Reference: Cambridge Crossing Parcel H Design Review Revision
Cambridge Crossing Parcel G Design Review Revision
Request for Minor Amendment
PB #179
Cambridge, Massachusetts

DESIGN REVIEW REVISION

BUILDING G AND BUILDING H PEDESTRIAN BRIDGE - CDD STAFF MEETING COMMENTS FROM VIRTUAL MEETING ON MAY 24, 2021

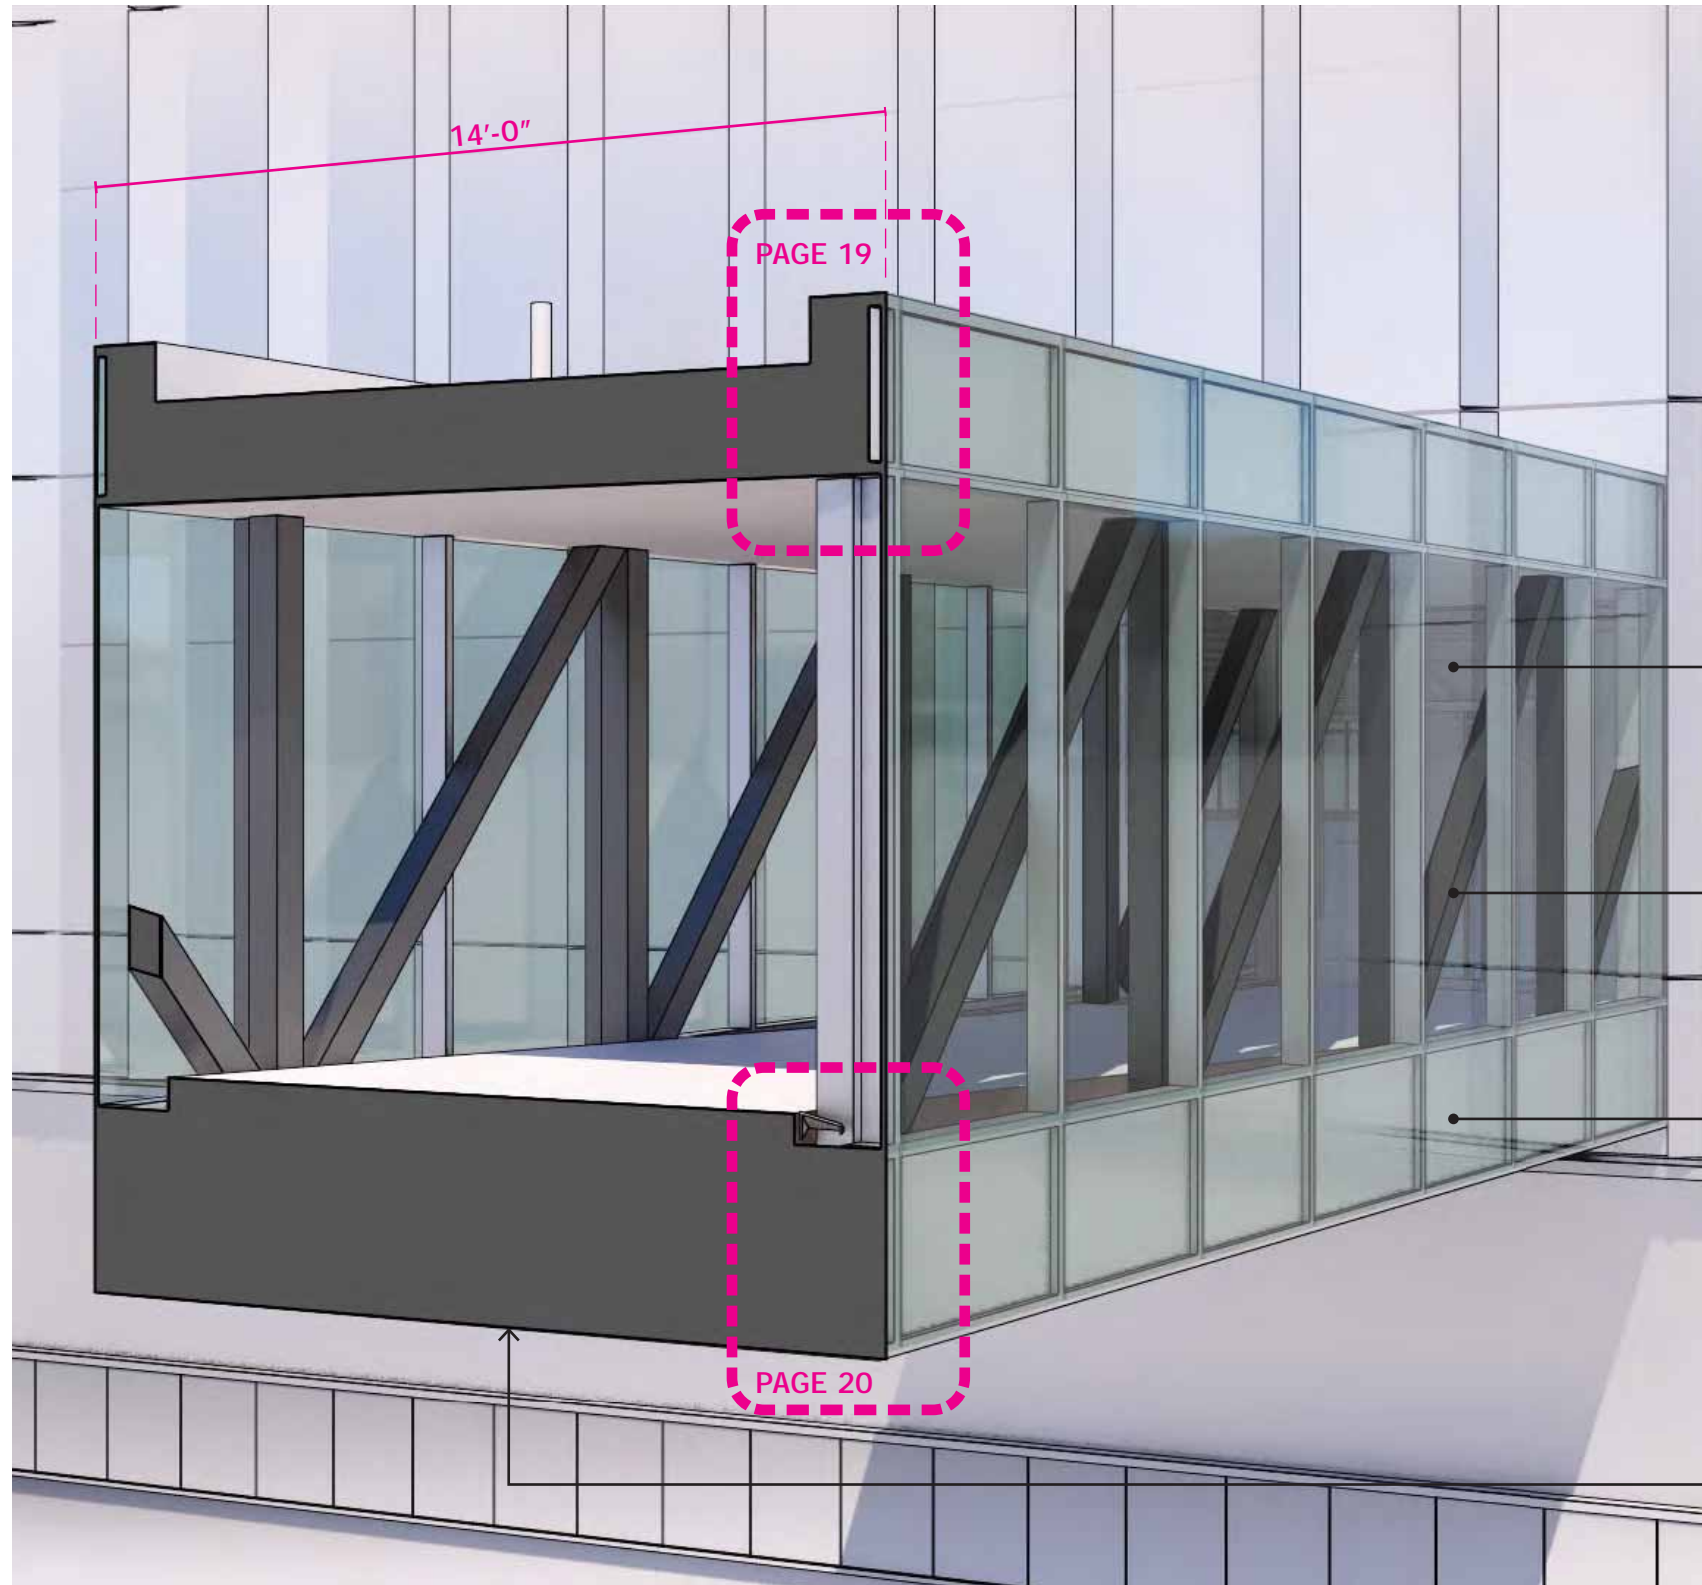
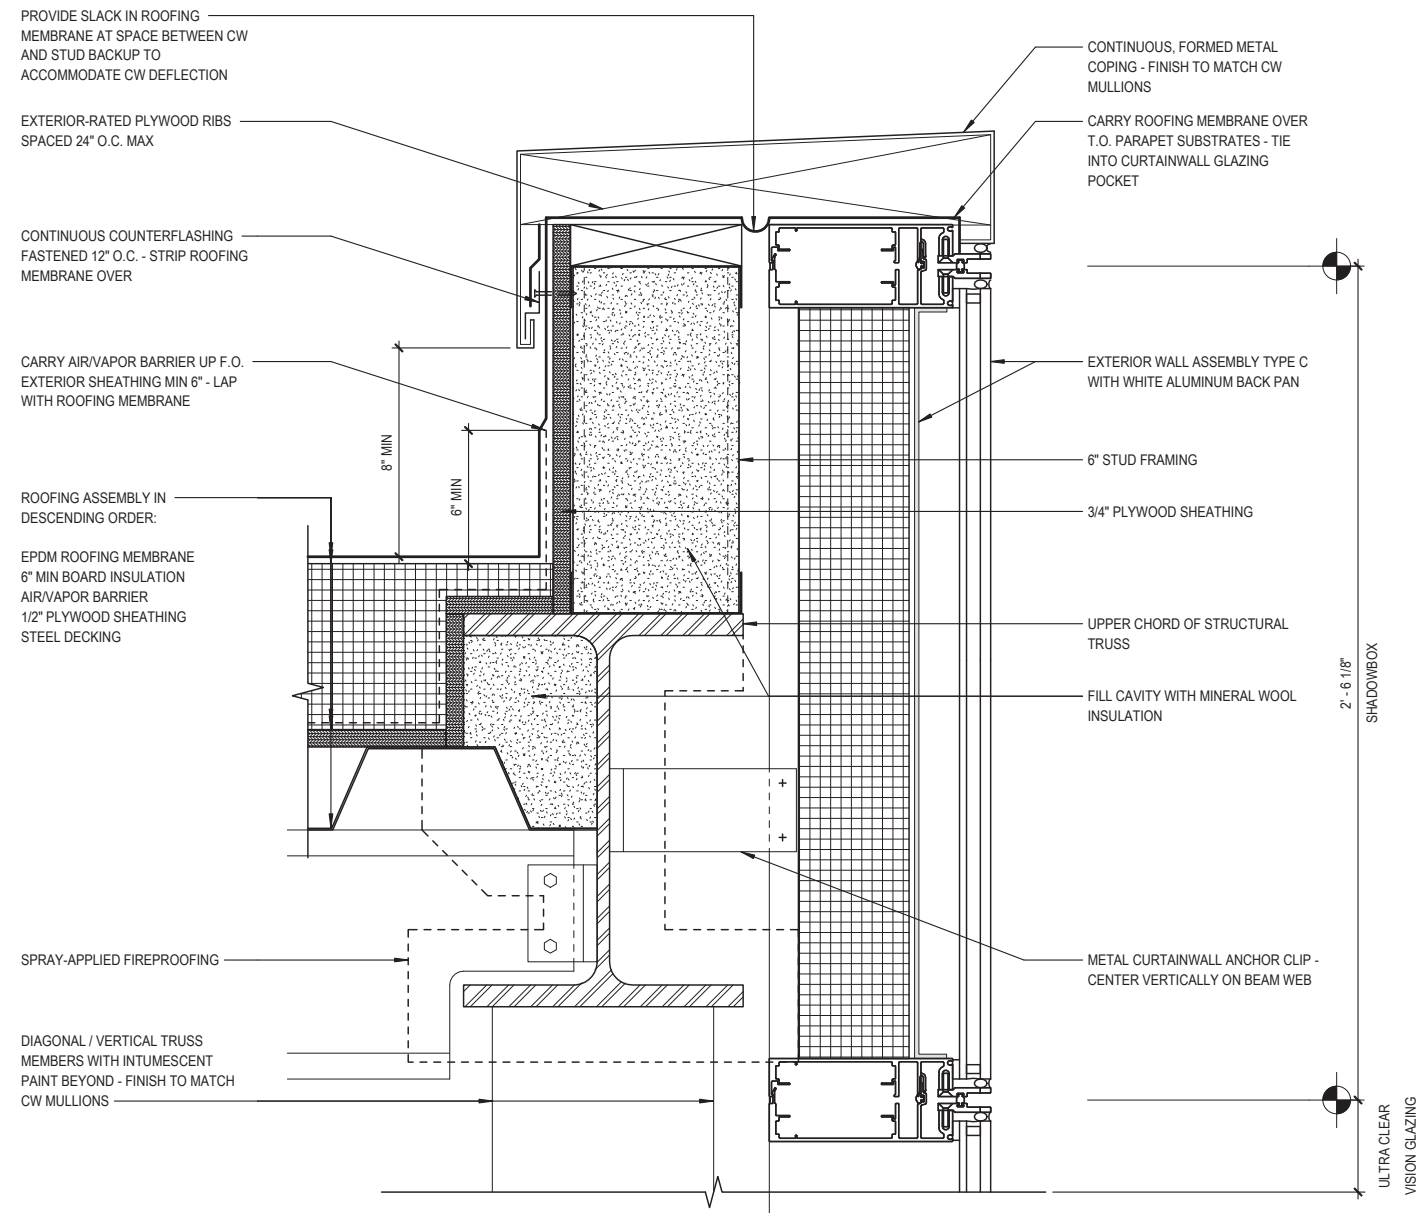
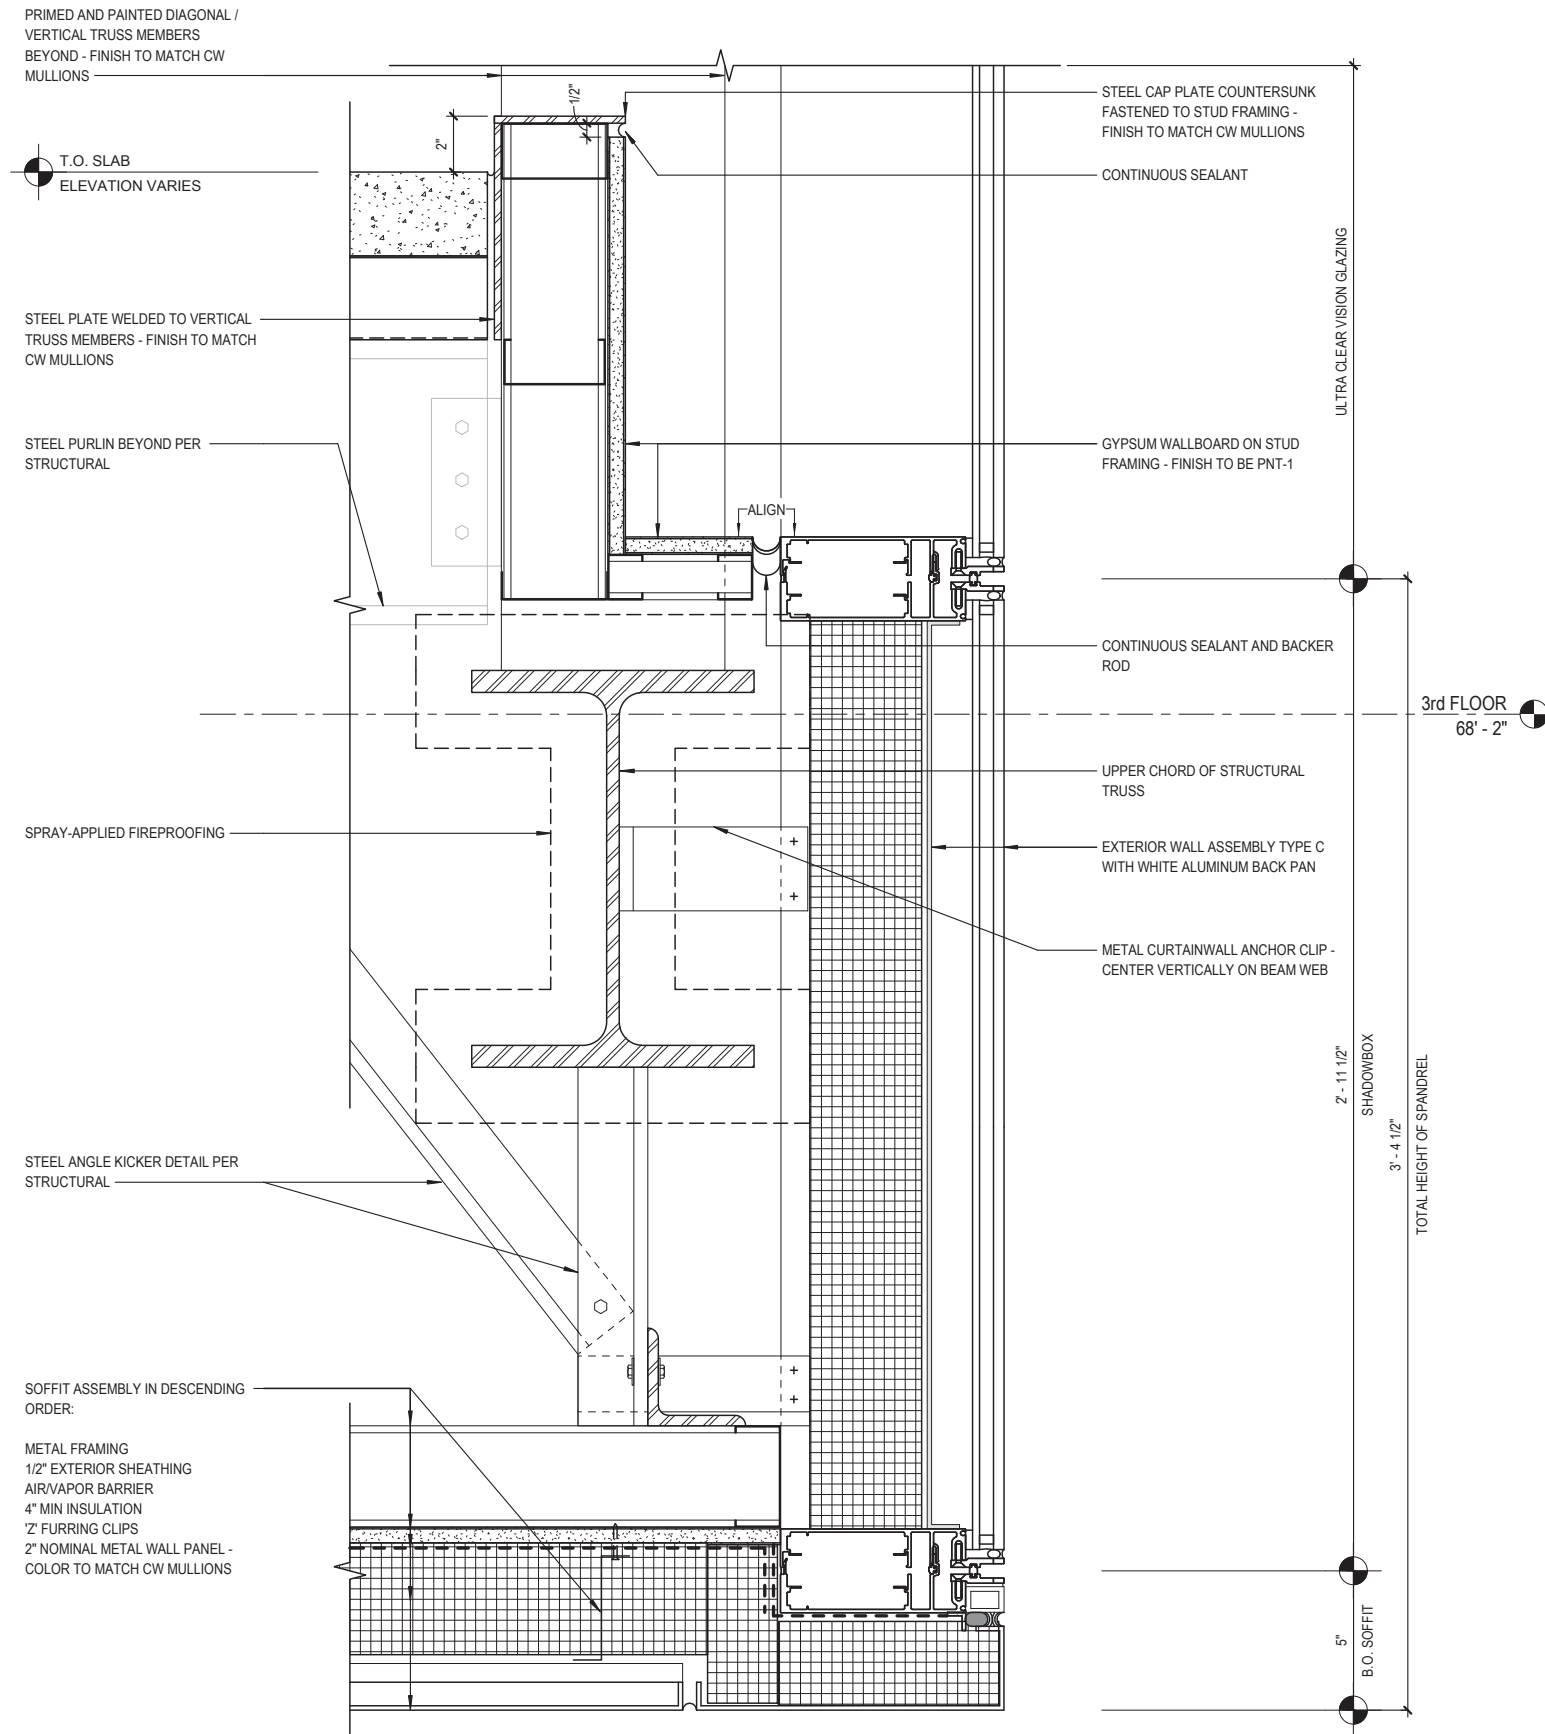
a. <i>Can the glass be more transparent?</i>	Yes - We have changed glass based on staff comments and selected the 1 1/8" IGU (High-VLT Insulated Glazing Unit) which was the same glass used at the main building lobby's curtainwall to address previous CDD transparency concerns. This glass will be used as the vision glass for both pedestrian bridges.	18	Yes

b. <i>Can the structure be expressed more?</i>	Yes - We have changed the paint finish on the structure based on staff comments. The exposed structure will be primed and painted to match the darker, Pewter color of the curtainwall mullions. This will contrast with the ultra-transparent glass and light shadowbox color to make it more apparent. The change to a more transparent glass will help express the structure when viewed from the ground plane.	18	Yes

i. <i>What is the spandrel material?</i>	The spandrels are glass with a painted metal shadow box back panel. The glass material is the same as noted in 5a above and the color of the painted metal shadow box back panel is UC1345XL Duranar XL white silver (3 coat) using UC51742 Primer & UC134595 clear-coat. This finish is similar to the vertical fins of Building H and the horizontal sun shades of Parcel G.	18	Yes
ii. <i>Can the spandrels be thinner?</i>	Yes - In response to staff comments we reduced the vertical dimension of the spandrel and increased the amount of vision glass. We were able to reduce the top spandrel dimension from 3'-3 1/2" to 2'-7 1/2" - a reduction of 8" (19.23%). We were able to reduce the bottom spandrel dimension from 3'-7 1/2" to 3'-4 1/2" - a reduction of 3" (6.9%).	18-20	Yes

6. <i>What is the material of the underside of the bridges?</i>	The underside of the bridges are composite metal panel.	18	Yes
a. <i>Can the color of the metal panel on the underside of the bridges be a lighter color?</i>	Yes - We have changed the metal panel finish based on staff comments and selected three coats of Valspar 399C049 Fluropon Classic II - Pewter	18	Yes

ULTRA-CLEAR VISION GLASS

PAINT-COATED STRUCTURAL TRUSS

GLASS SHADOW BOX

COMPOSITE METAL PANEL SOFFIT

METAL PANEL SOFFIT
 COLOR: (3) Coats of Valspar 399C049
 Fluropon Classic II - Pewter

ULTRA-CLEAR VISION GLASS
 1 1/8" IGU (High-VLT Insulated Glazing Unit)

SHADOW BOX GLASS
 1 1/8" IGU (High-VLT Insulated Glazing Unit)

SHADOW BOX GLASS
 UC1345XL Duranar XL white silver (3 coat)
